AGREEMENT

WHEREAS, the CRA desires to retain the services of the Contractor to provide the goods and services in accordance with the CRA's Invitation to Bid No. 2022-01-R, and the Contractor's response thereto, all of which are incorporated herein by reference.

S10

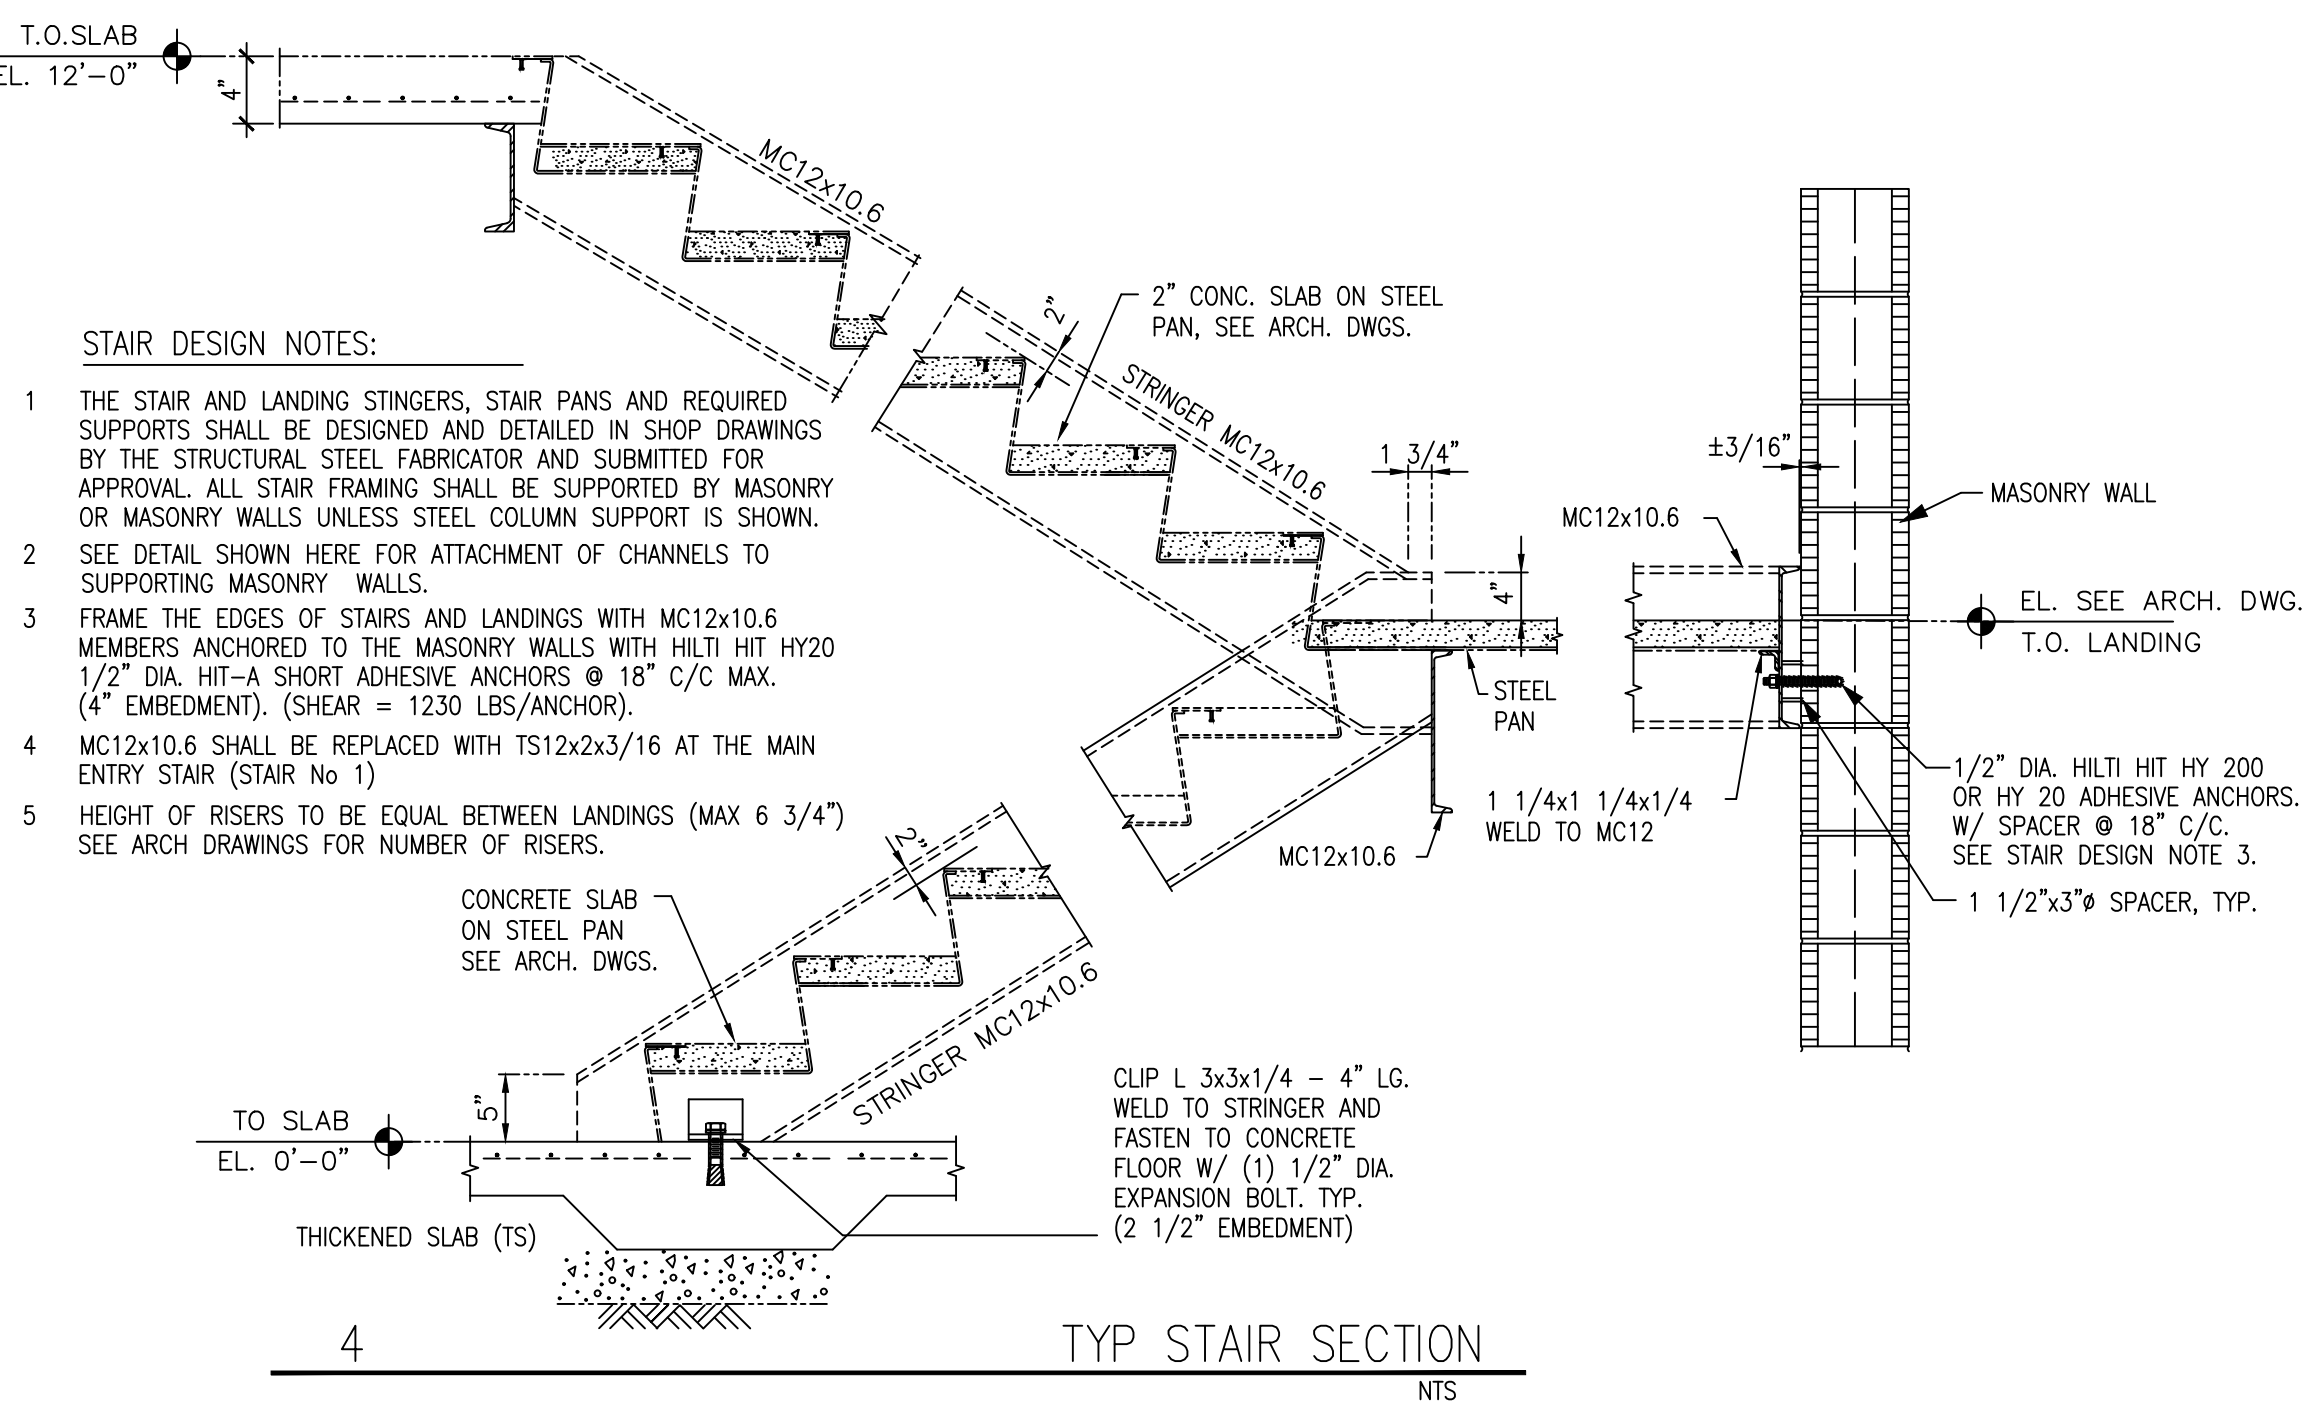
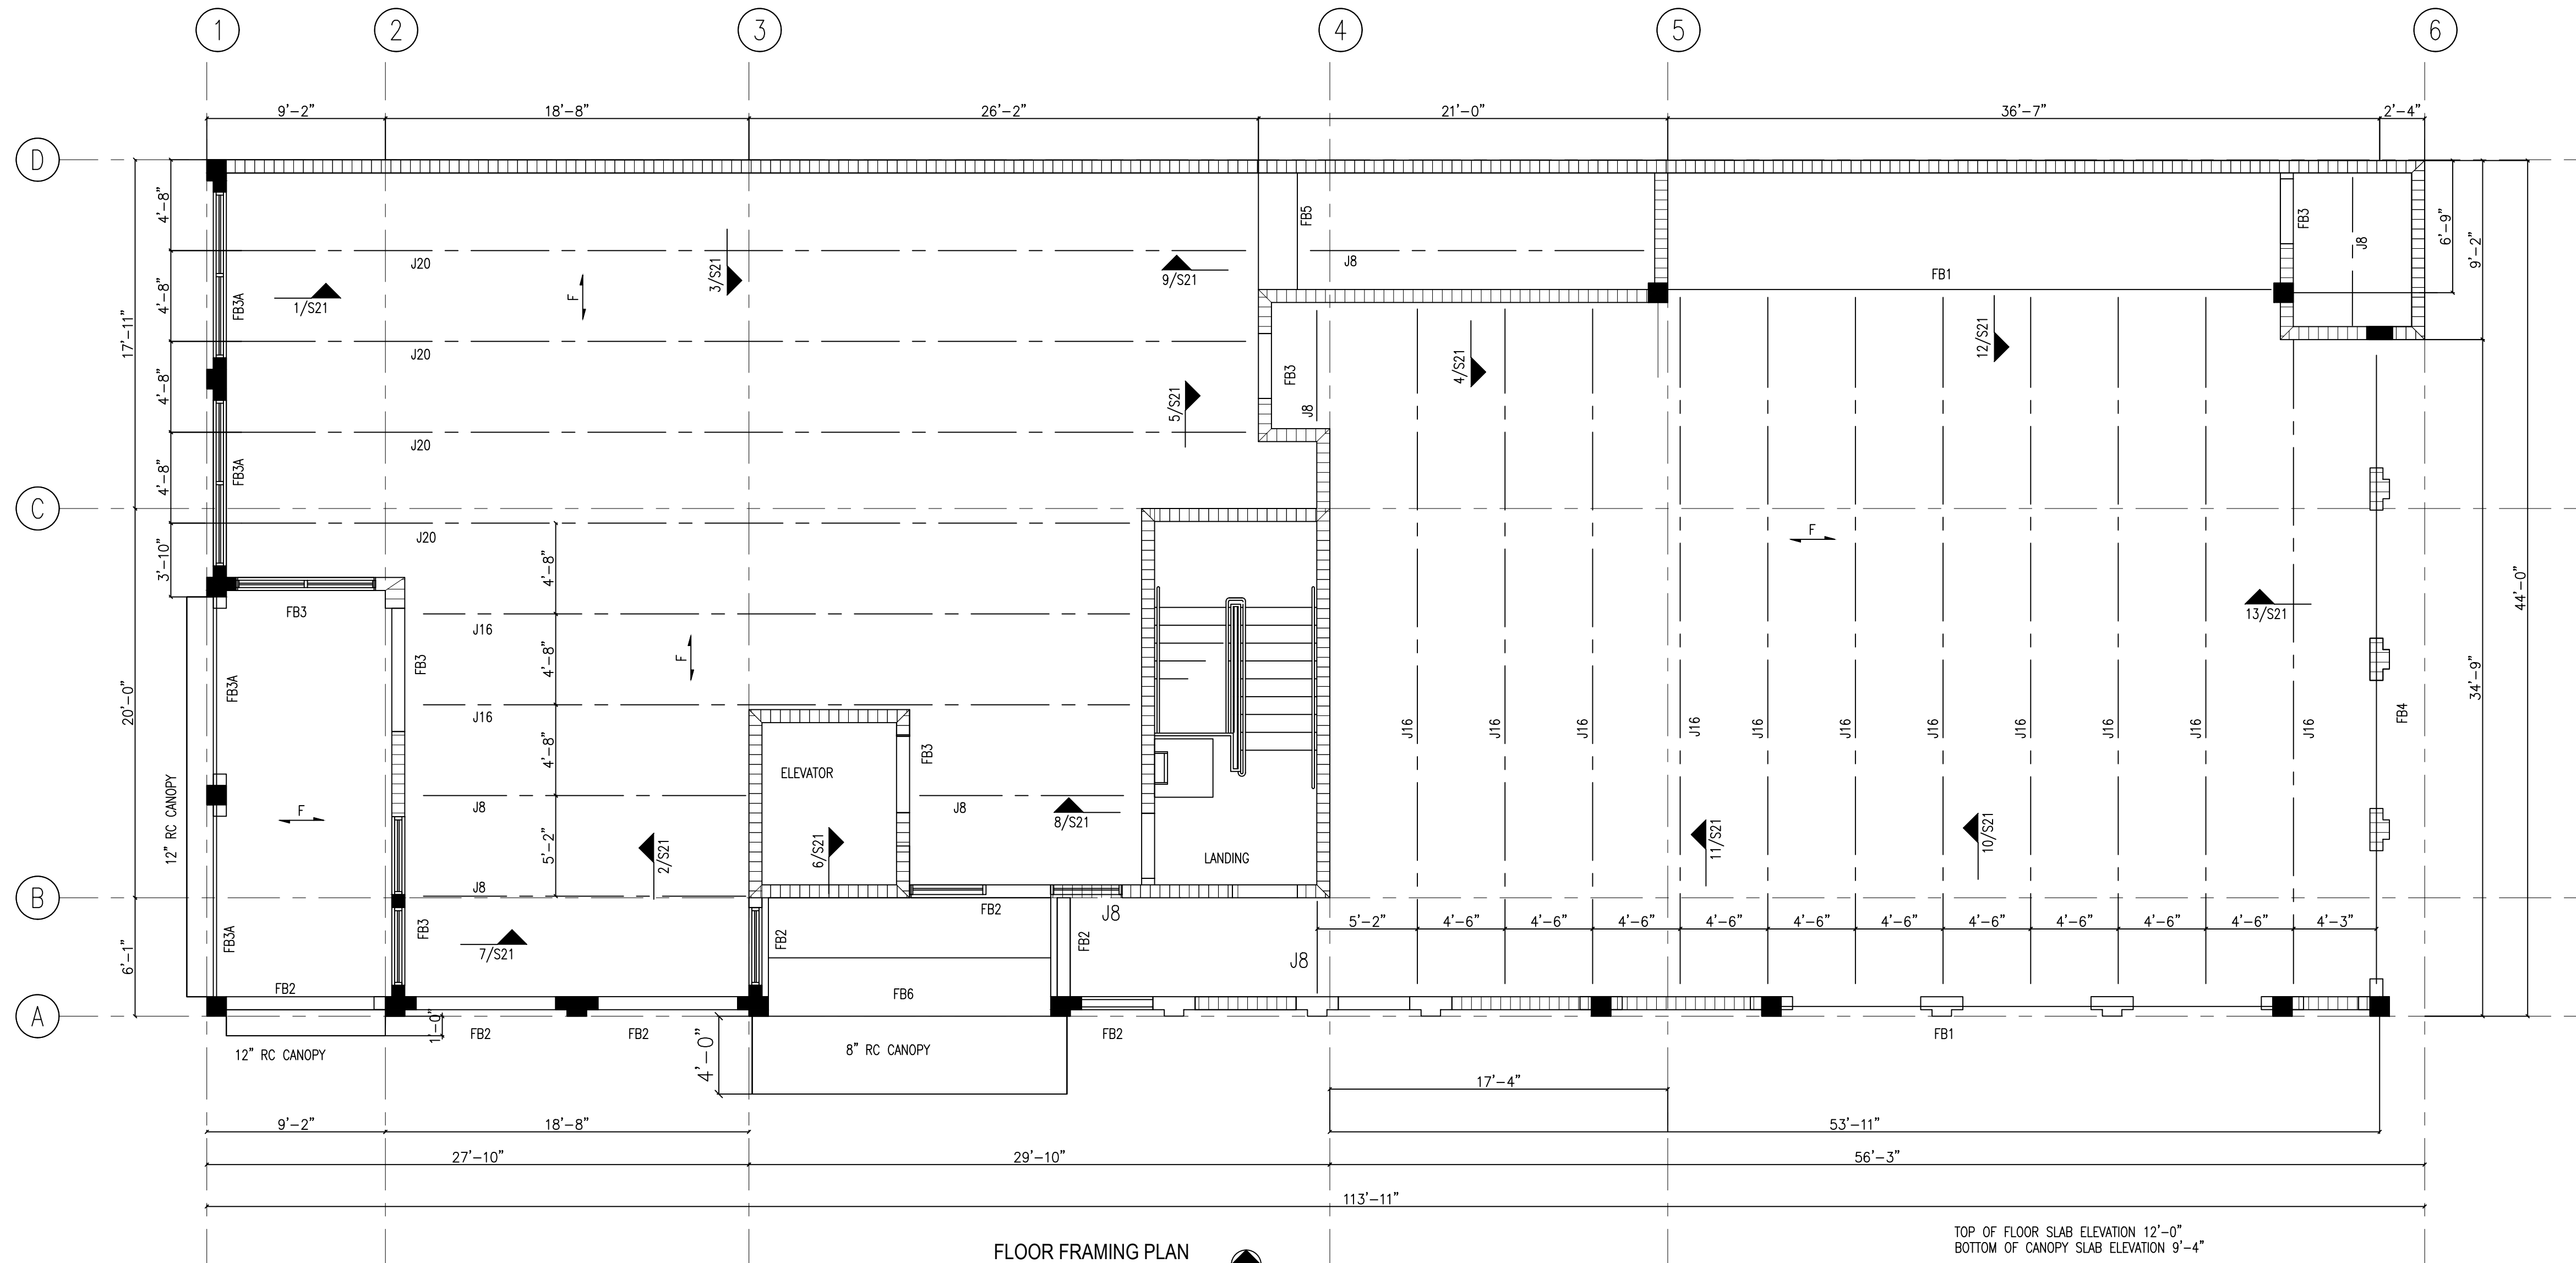
18. **F36 shows on the spread footing schedule, but it is not show on the floor plan (Drawing S10), please clarify.**

19. **C1 square appearance on the floor plan does not match with the square appearance of the column schedule (Drawing S10) , please clarify.**

20. **Two columns do not have marks (Drawing S10). Please clarify.**

F36 not used in the project. Drawing S10 is attached to this Addendum.

C1 is a square column sometimes with poured wall attached. Drawing S10 is attached to this Addendum.

C1 at grid line 1D, wall at grid line 2B. Drawing S10 is attached to this Addendum.
